Access Compliance Report

Public Rights-of-Way

(Curb Ramps)

Intersection ID: 9172	Main Street: E_CRAIGHEAD_RD	Cross Street: N_TRYON_ST	Location: NE
ADA ID: 9252E7F0D369	Ramp Type: Perp	Initial Pass/Fail: Fail	Overall Compliance: No
Severity Score: 22.5			
Codes/Mitigation Info/Possible Solution		Field Measurements/Component Compliance

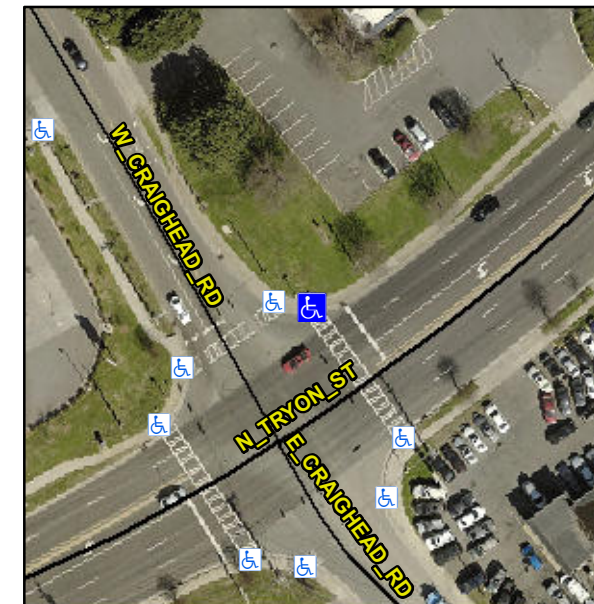
Not Found, R304.5.1, R304.2.2, R304.5.3

Compliance	Description	Data	Compliance	Description	Data
N/A	Ramp Length (in)	72.0	No	Ramp Slope (%)	8.6
No	Ramp Width (in)	43.5	No	Ramp XSlope (%)	2.5
N/A	Flare Type LT	N/A	N/A	Flare Type RT	N/A
N/A	Flare Slope LT (%)	N/A	N/A	Flare Slope RT (%)	N/A
N/A	Flare Traversable LT?	N/A	N/A	Flare Traversable RT?	N/A
N/A	Landing Length (in)	N/A	N/A	DWS Provided?	N/A
N/A	Landing Width (in)	N/A	N/A	DWS Contrast?	N/A
N/A	Landing Slope (%)	N/A	N/A	DWS Length (in)	N/A
N/A	Landing X Slope (%)	N/A	N/A	DWS Full Width?	N/A
N/A	Landing Curb? (Y/N)	N/A	N/A	DWS Offset (in)	N/A
N/A	Shared Landing?	N/A			
N/A	Gutter Ponding?	N/A	N/A	Gutter Slope (%)	N/A
N/A	Gutter Lip Ht (in)	N/A	N/A	Gutter X Slope (%)	N/A
N/A	Painted X Walk1?	Yes	N/A	Painted X Walk2?	N/A
	X Walk 1 Direction	To SE		X Walk 2 Direction	N/A
N/A	X Walk 1 Width (in)	86.0	N/A	X Walk 2 Width (in)	N/A
	X Walk 1 Slope (%)	0.1		X Walk 2 Slope (%)	N/A
	X Walk 1 X Slope (%)	1.1		X Walk 2 X Slope (%)	N/A

Remove & Replace Entire Ramp.
